Additional Ecology Response to Section 92 Questions for a Proposed Subdivision 2127 Kaipara Coast Highway, Makarau

Contract Report No. 5807c

August 2024

Abib (Oamaru) Ltd
PO Box 302247
North Harbour
Auckland 0751

SEA and SEA quality vegetation map

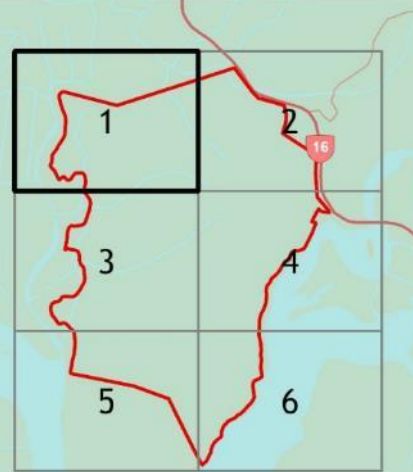
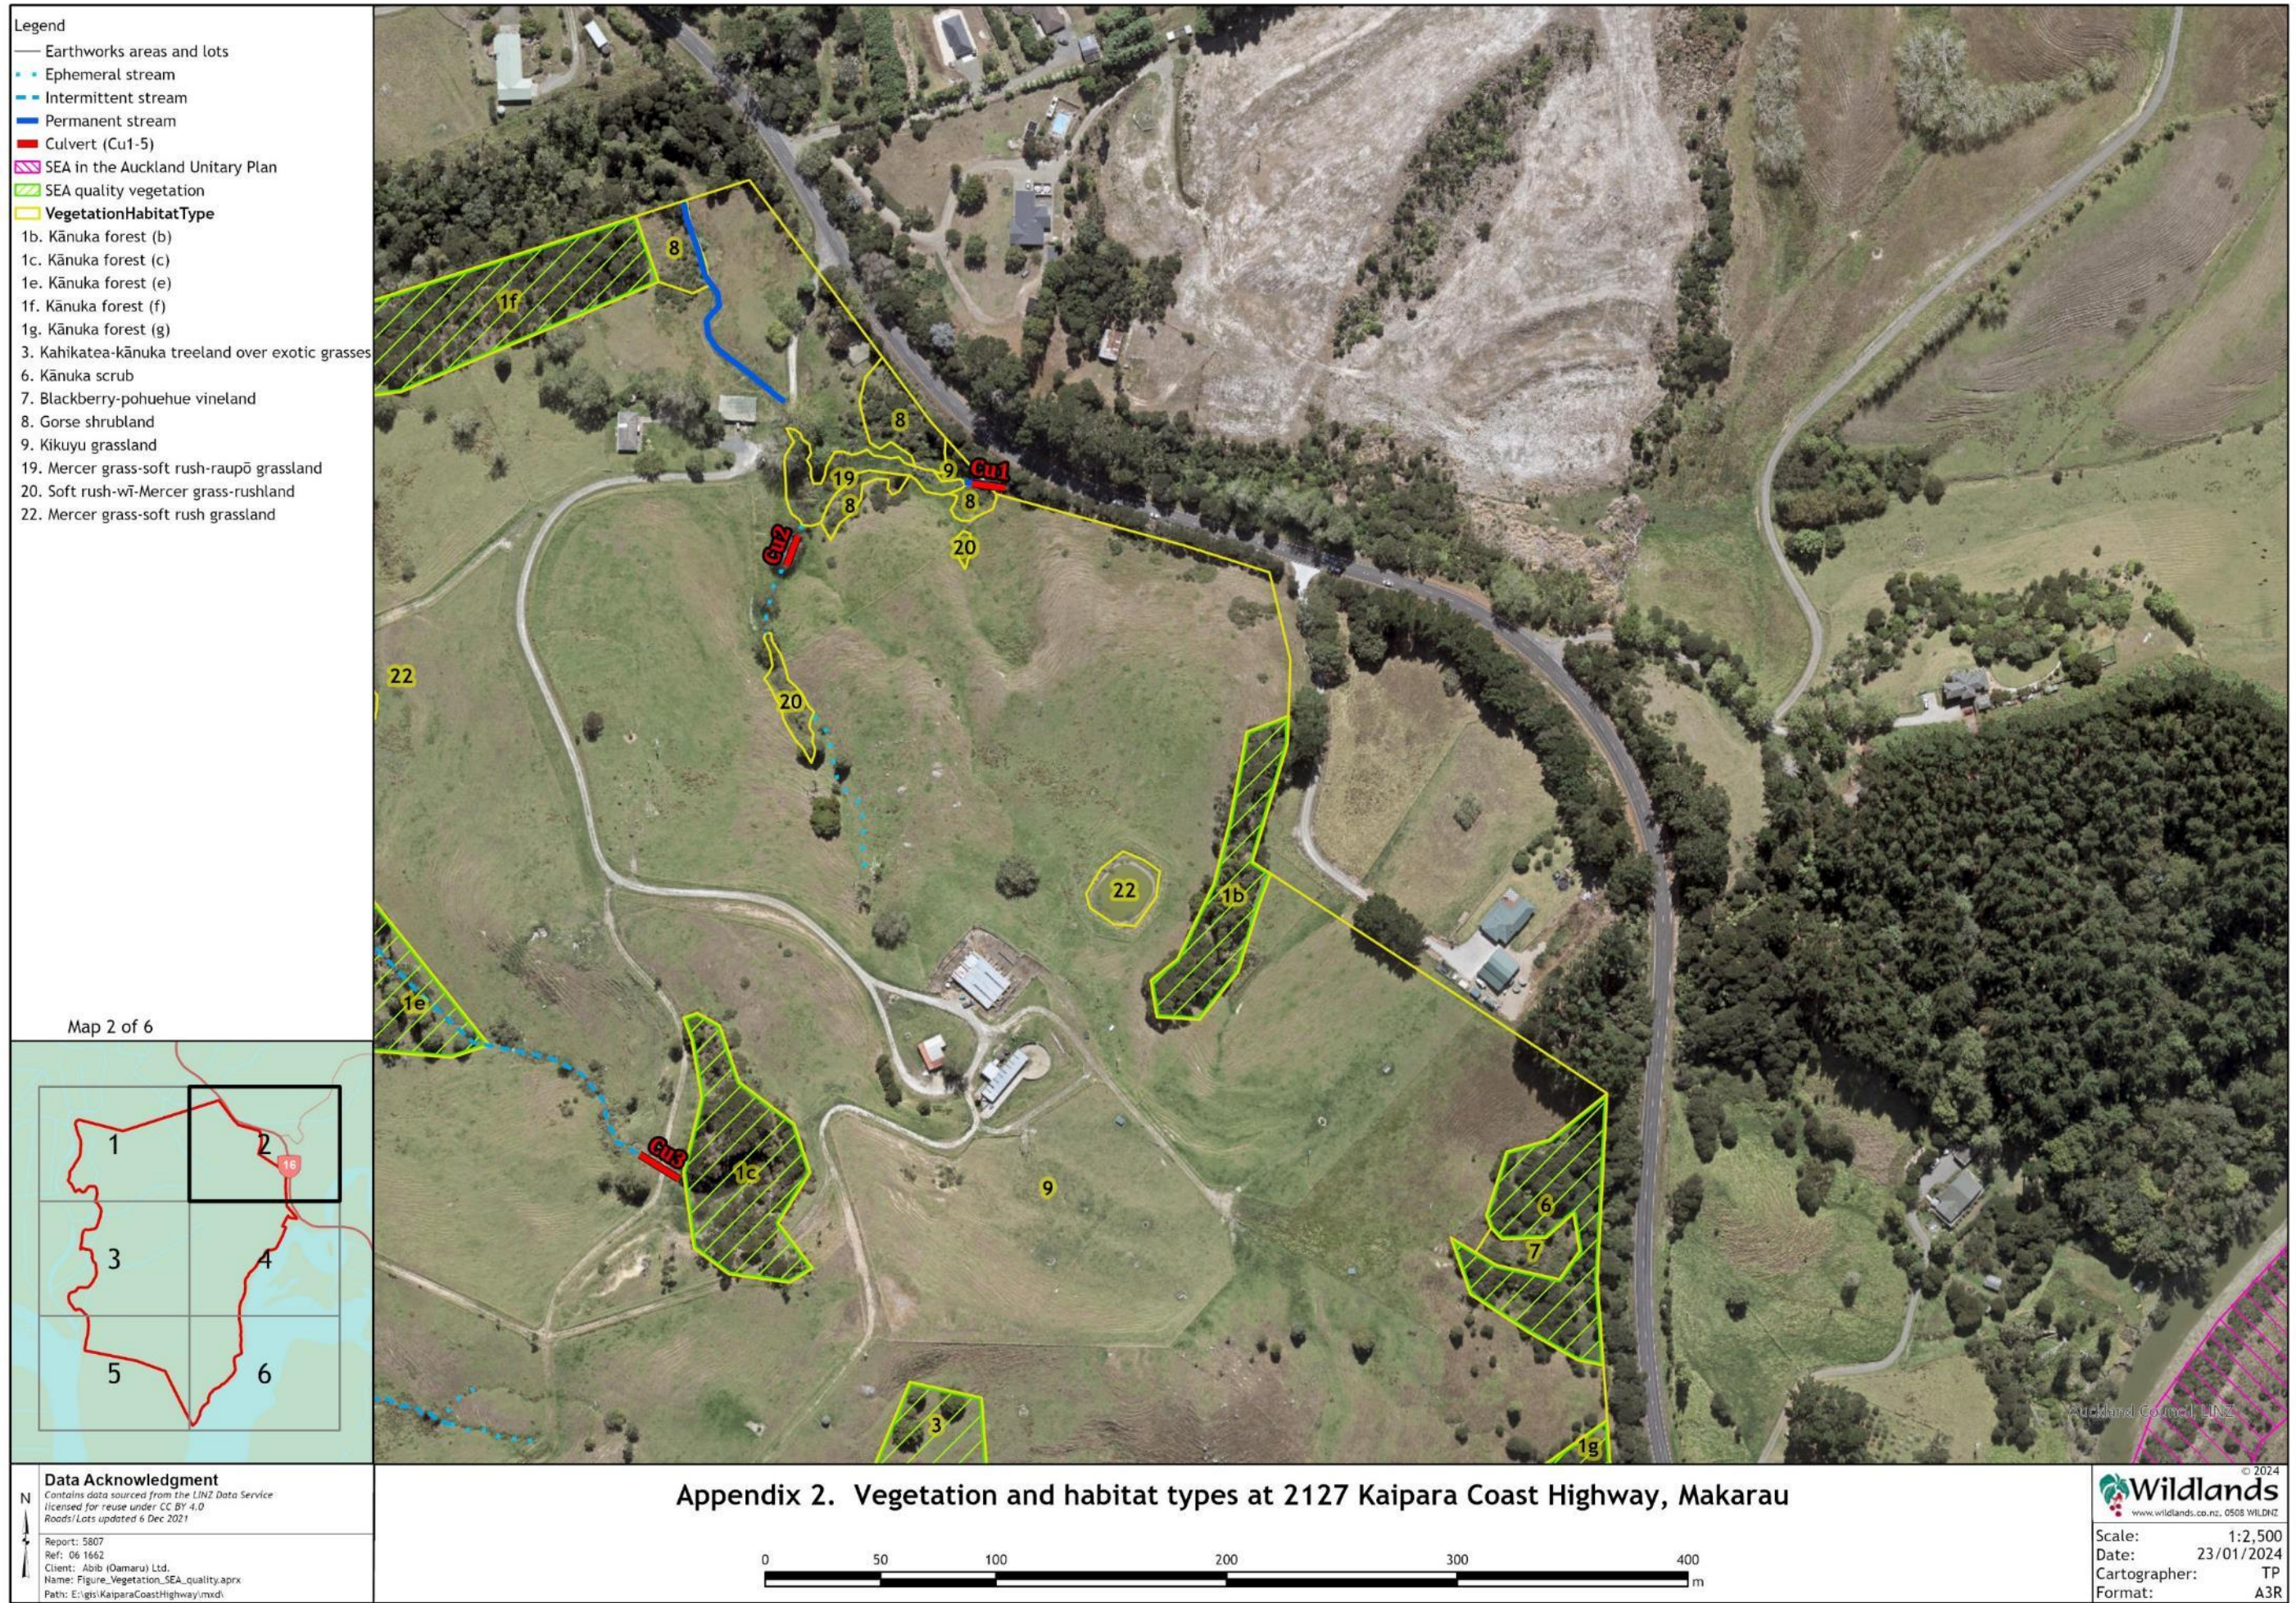
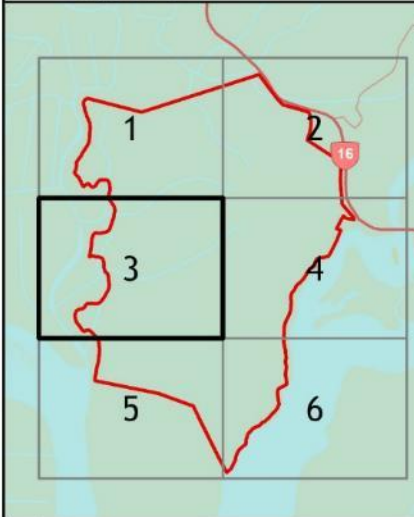
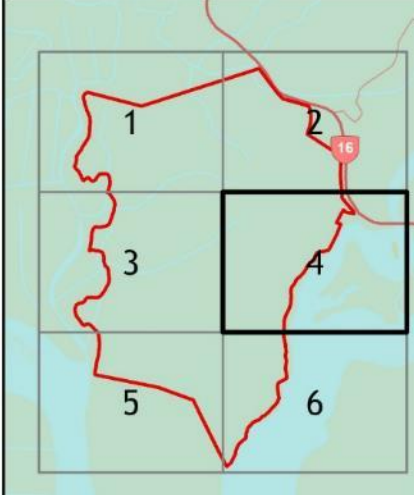
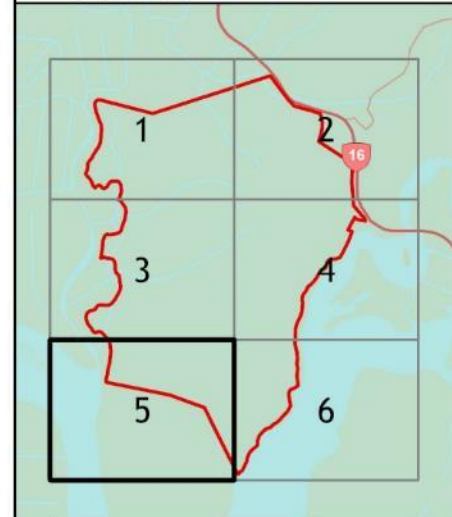
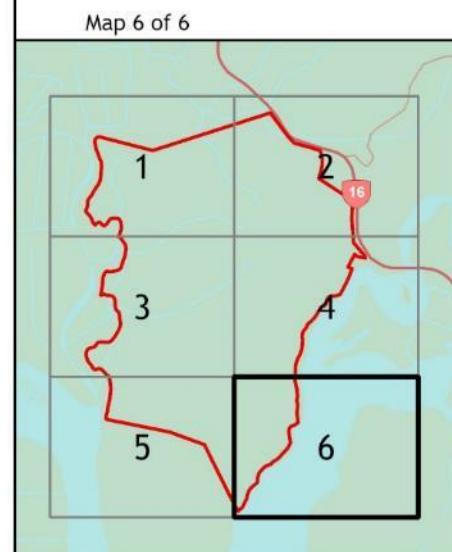
A plan is requested as per E39.6.1.6 clearly identifying SEA areas and other areas of indigenous vegetation, wetlands, and watercourses on site.

Please provide an assessment of areas of vegetation proposed for protection that are already identified as SEA or areas meeting the factors for Significant Ecological Areas in Policy B7.2.2(1) and confirm the areas (m²) each of the areas within the site cover.

An ecological features map has been provided. However, Council's ecologist does not agree with the number of areas that have been mapped as SEA quality. Most of those not already mapped as SEA are small and tree or shrubland of common pioneer species with many heavily grazed beneath and would not meet the criteria for threatened species nor stepping stones. No fauna survey has been undertaken confirming the presence of rare and threatened species with these just having the potential to be present at the site. Vegetation cannot be identified to meet the threat or rarity factor without evidence to confirm their presence. There are many patches of vegetation in the wider landscape such that those on site not currently mapped as SEA cannot be considered even "when aggregated make an important contribution to the provision of a particular ecosystem in the landscape" noting that most of the ecosystems on the site are not rare or threatened.

The areas of SEA quality vegetation have been cumulatively assessed in the EclA rather than each area of vegetation individually. It is likely that should each of the areas be assessed individually it would be found that the SEA criteria for most of those not already mapped as SEA would not be met. Assessment is required of protection areas on a finer scale. See comments above related to response to Q47.

The maps provided in the original Ecological Impact Assessment (EclA) have been updated to include the SEA overlay and any areas that are of ‘SEA Quality’ (Appendix 2). As outlined in the EclA, this includes all areas of forest, treeland, and scrub at the site as they are likely to provide habitat for indigenous fauna species that have been classified as ‘Threatened’ or ‘At Risk’ (Factor 2b: Threat status and rarity). These fauna habitat values are discussed in more detail in Section 6 of the EclA. These vegetation types also form part of a network of sites that cumulatively provide important habitat for indigenous fauna (Factor 4c: Stepping-stones, migration pathways and buffers).

All natural inland wetland areas that are dominated by indigenous plant species also meet the criteria to be classified as SEA (Factor 2d: Threat status and rarity) and have therefore been mapped accordingly (Appendix 2).

I disagree with this assessment as most of the forest remnants on the site are not simply "small and tree or shrubland of common pioneer species". Most feature trees of regenerating or remnant secondary species such as pūriri (*Vitex lucens*), kauri (*Agathis australis*), kahikatea (*Dacrydium dacrydioides*), tōtara (*Podocarpus totara*), rimu (*Dacrydium cupressinum*), kohekohe (*Didymocheton spectabilis*), tānekaha (*Phyllocladus trichomanoides*), and rewarewa (*Knightia excelsa*). The Council's assessment also seems to apply a new interpretation to the 'Stepping stones, migration pathways, and buffers' criterion. This criterion does not require that the ecosystems/habitats that are "part of a network of sites that cumulatively provide important habitat for indigenous fauna" be rare or threatened in their own right. I also note that long-tailed bats (*Chalinolobus tuberculatus*) have been recorded on the boundary of the site, have very large home ranges, and are known to forage over farmland and roost in small forest patches and isolated trees.

Revised map of Wetland 11

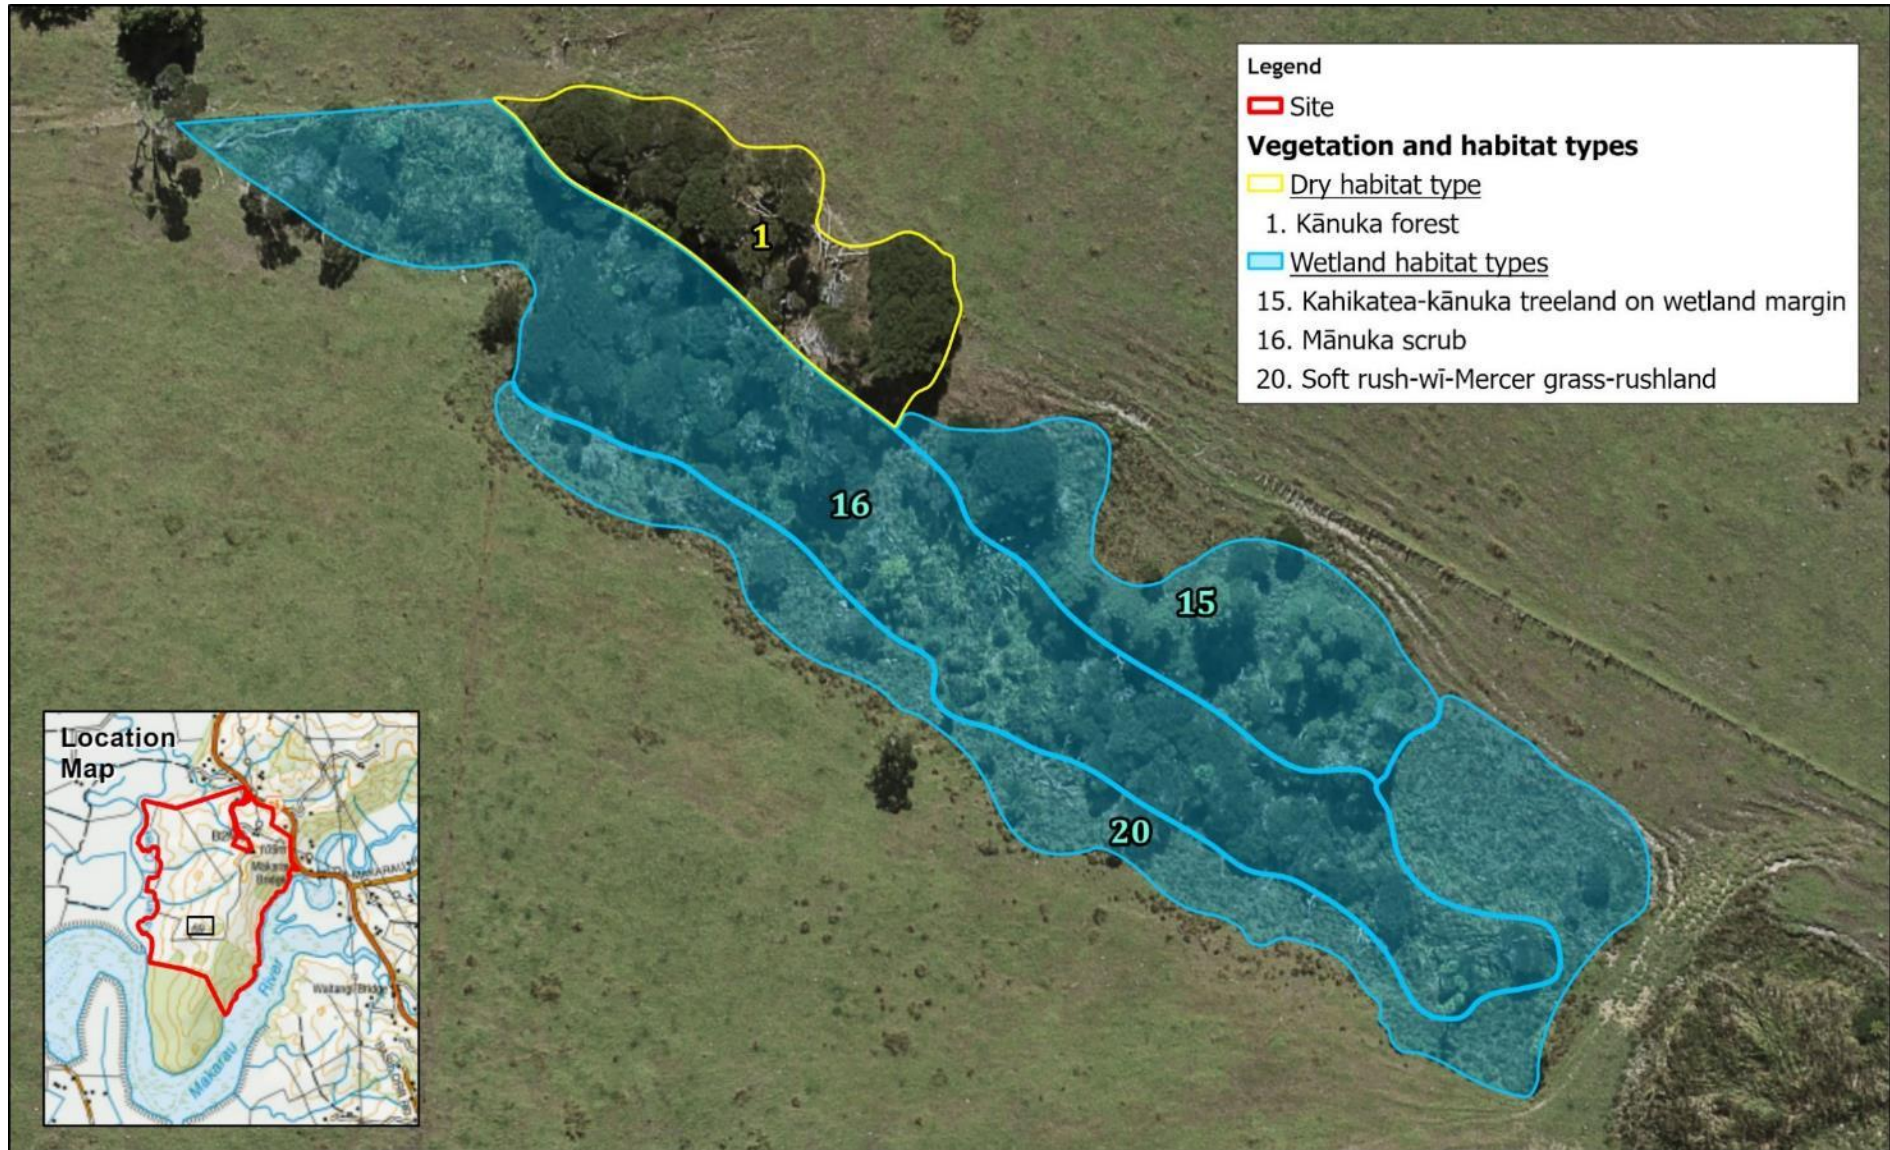
While most of the vegetation appears to be correctly mapped there are some areas that a greater area is covered as mapping is shown at a coarse scale. One location noted is on the southern edge and northeastern end of wetland 11 (areas 15 and 16 in the ecological assessment) where wetland rushes are located beyond the mapped area. Correct vegetation extent is especially important in the case of wetlands where wastewater dispersal fields are proposed in proximity to these to ensure required offset is provided. Please provide updated plans and information.

The information provided on wetland extent is not sufficient to be able to concur with findings. No formal wetland delineation including vegetation plots, hydrology and soils assessment was undertaken with extent based on a rapid assessment. It is likely that following a full wetland delineation that many of the less rushy areas that have been excluded would be found to also meet the criteria for natural wetland such that the extent would be larger than has been shown. Note that the pasture exclusion methodology also cannot be used as part of excluding an area as natural wetland when completing a wetland delineation in the case of residential development.

Wetland 11 was revisited on 11 December 2023 to reassess the boundary. A revised boundary map has been provided (Appendix 3). While some areas of scattered rushes fall outside of the new mapped boundary, these are much sparser than within the wetland area. As such, the pasture grasses and herbs continue to be dominant in the areas that have been excluded.

Ground conditions were also considered during the assessment, with the soil within the wetland area being damp to saturated, while outside of the new boundary it was dry.

There are differences between the new boundary and that shown in the original report. However, these are minor and they extend in both directions (i.e., in some areas the new line goes out, and in others it goes in from the original boundary). The largest change is the reclassification of a small area of kānuka as a dryland habitat.

The “formal wetland delineation” protocols allow for the identification of wetlands using the rapid test (as per Figure 1 from the Ministry for the Environment’s pasture exclusion methodology, provided below). In this case the area that was clearly wetland was identified using this method and as such, vegetation plots, soil assessments, and hydrology assessments are not required.

In the event that the rapid test is inconclusive, the use of vegetation plots, soil assessments, and hydrology assessments allow an ecologist to determine if the specific locations where these assessments were made are within a wetland. However, they will not identify exactly where the boundary of the wetland is along its entire perimeter. According to the pasture exclusion methodology, mapping the perimeter of a wetland that meets the rapid test should be carried out by walking around the site with a GPS enabled device (see Section 6.5 of the pasture exclusion methodology). This is what was done in this case, and the resulting line was further refined using easily identifiable land marks visible in aerial imagery.

Council’s ecologist is correct that areas of wet pasture should not be excluded from being classified as natural inland wetland on the basis of the pasture exclusion if the land use is to be changed from pastoral grazing. However, in this case the area outside the mapped wetland was not wet pasture. At the time of the site visit this area was dry and dominated by FACU species including kikuyu (*Cenchrus clandestinus*), brown top (*Agrostis capillaris*), narrow-leaved carpet grass (*Axonopus fissifolius*), and narrow leaved plantain (*Plantago lanceolata*). A photograph of the southern boundary of Wetland 11 is provided below (Plate 1).
